STAFF REPORT: 09-08-2021 MEETING

APPLICATION NUMBER: 21-7400

ADDRESS: 630 VIRGINIA PARK

SCOPE OF WORK: REPLACEMENT OF HISTORIC WINDOWS* (WORK COMPLETED WITHOUT APPROVAL)

Window 1, 9/1 divided light South Elevation Window

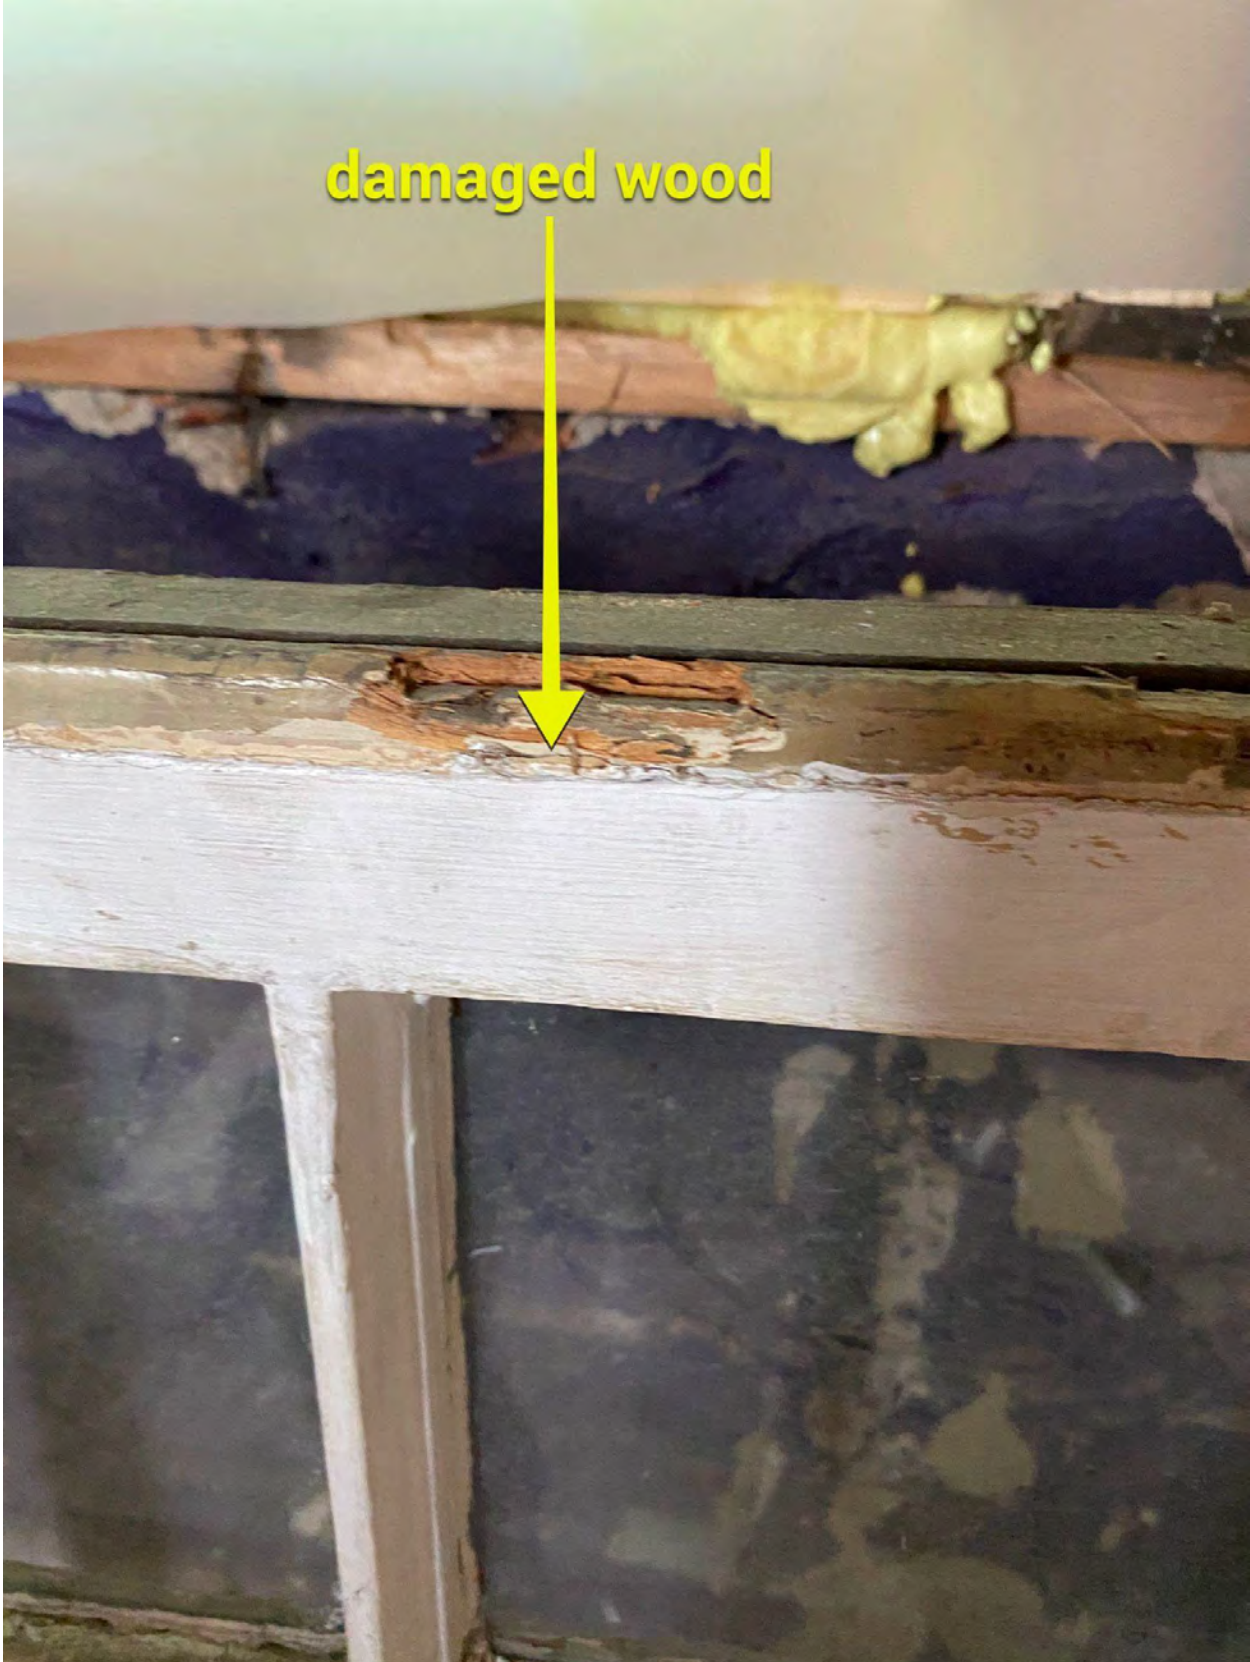
all glazing needs replacement

Rot and mold

Window 5 , 9/1 divided light South Elevation

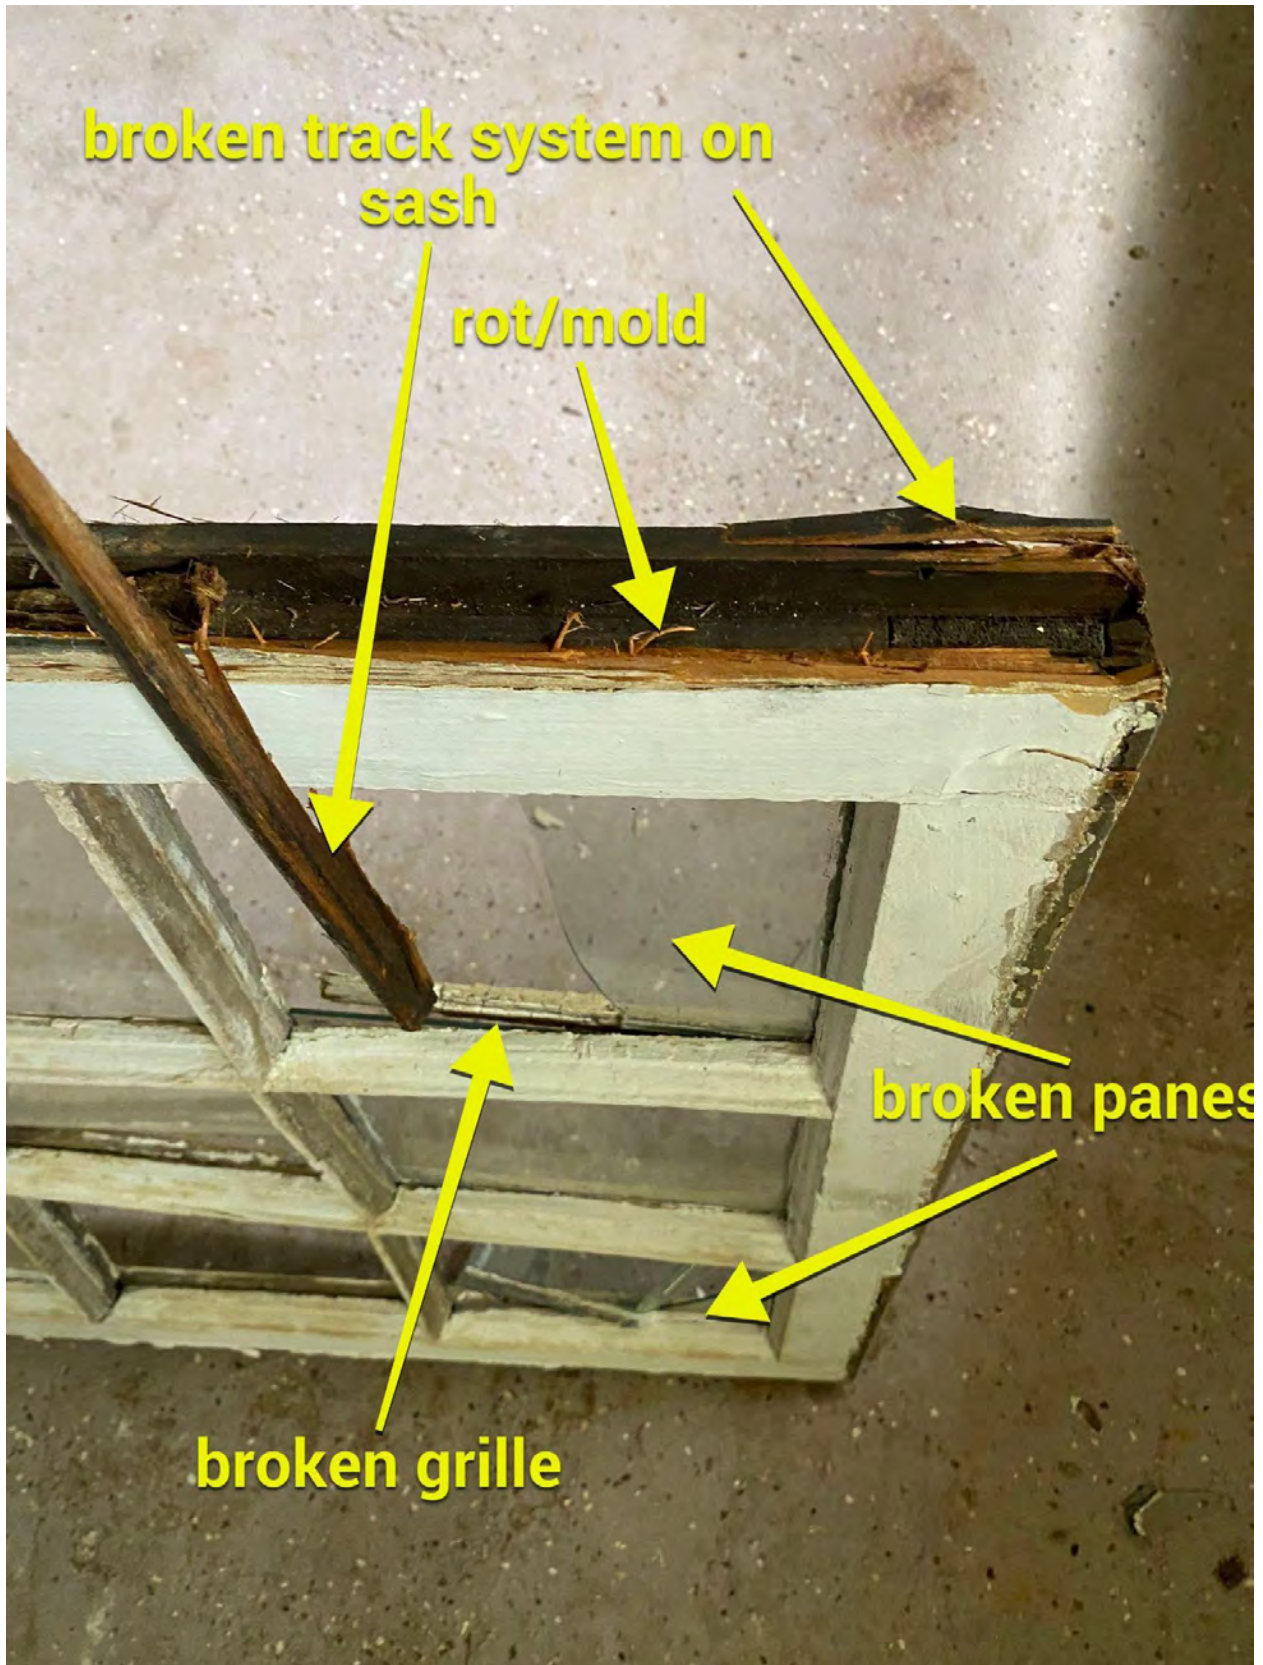
damaged grille profile

broken grille

broken glass

Examples of typical damage

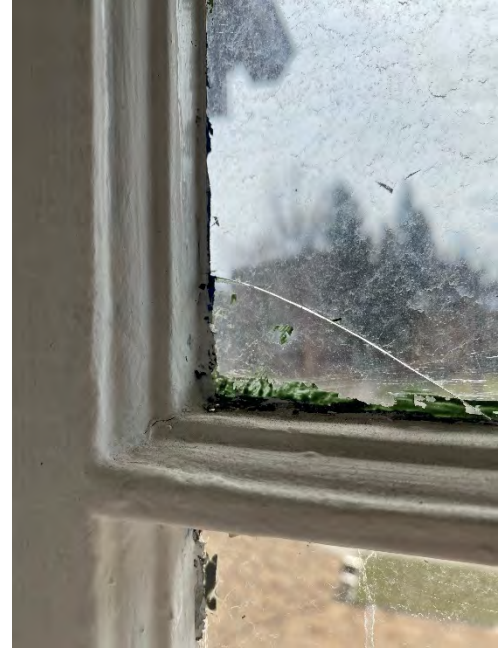
Broken Glass

Operating hardware missing or inoperable

Rot at window sashes
